Well Name: STACK CATS 25_36 FED COM	Well Location: T22S / R32E / SEC 25 / NWNE / 32.3694991 / -103.6254599	County or Parish/State: LEA / NM
Well Number: 14H	Type of Well: OIL WELL	Allottee or Tribe Name:
Lease Number: NMNM2379	Unit or CA Name:	Unit or CA Number:
US Well Number: 3002554426	Operator: OXY USA INCORPORATED

Type of Submission: Notice of Intent

Type of Action: APD Change

Procedure Description: OXY USA Inc., respectfully requests to amend the subject AAPD to revise the SHL, BHL, Well Pad, TVD and Drill Plan. Old SHL: 210' FNL 1749' FEL New SHL: 1098' FNL 1255' FEL Old BHL: 20' FSL 2250' FEL New BHL: 20' FSL 2510' FWL Old Well Pad: REDTNK_T22SR32E_2504 New Well Pad: REDTNK_T22SR32E_2506 Old TVD: 9570' New TVD: 9612' *THERE IS NO ADDITIONAL SURFACE DISTURBANCE RELATED TO THIS SUNDRY" Attached is the updated C102, drill plan, directional, Blanket Design and APD Change Worksheet.

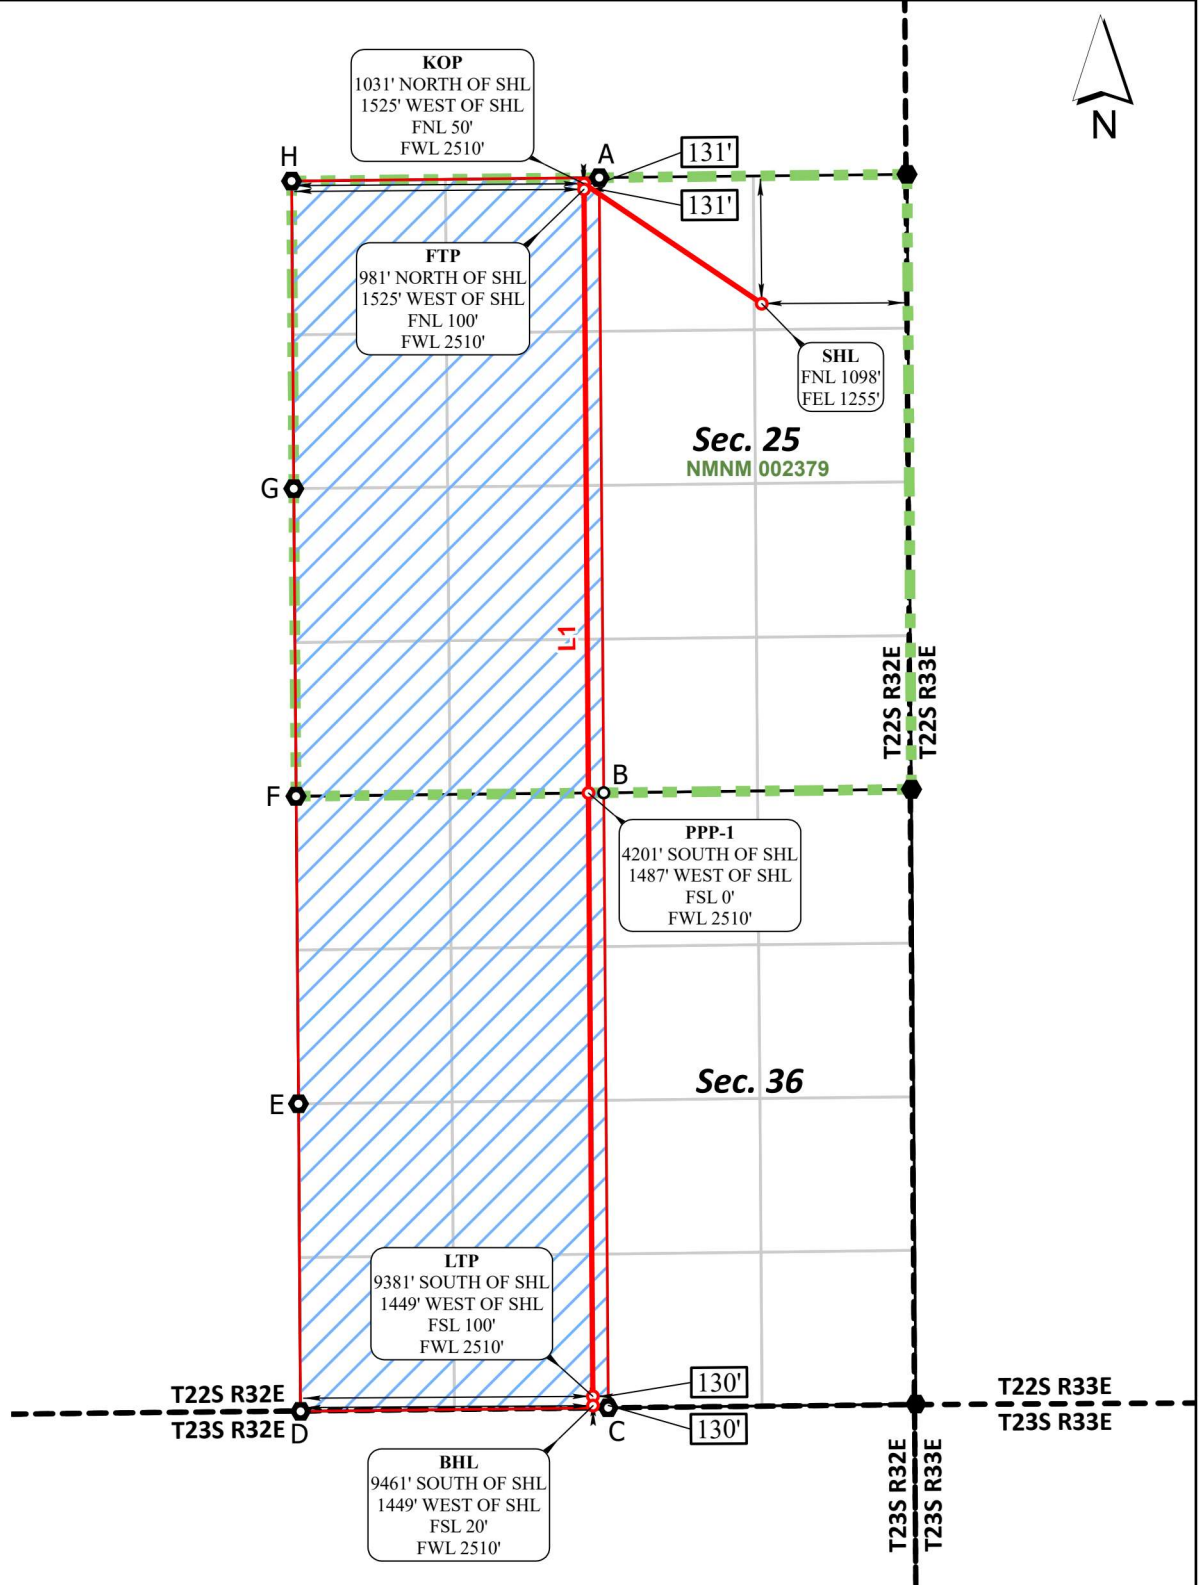
OXY USA Inc., respectfully requests to amend the subject AAPD to revise the SHL, BHL, Well Pad, TVD and Drill Plan.

Old SHL: 210' FNL 1749' FEL
New SHL: 1098' FNL 1255' FEL

Old BHL: 20' FSL 2250' FEL
New BHL: 20' FSL 2510' FWL

Old Well Pad: REDTNK_T22SR32E_2504
New Well Pad: REDTNK_T22SR32E_2506

Old TVD: 9570'

New TVD: 9612'
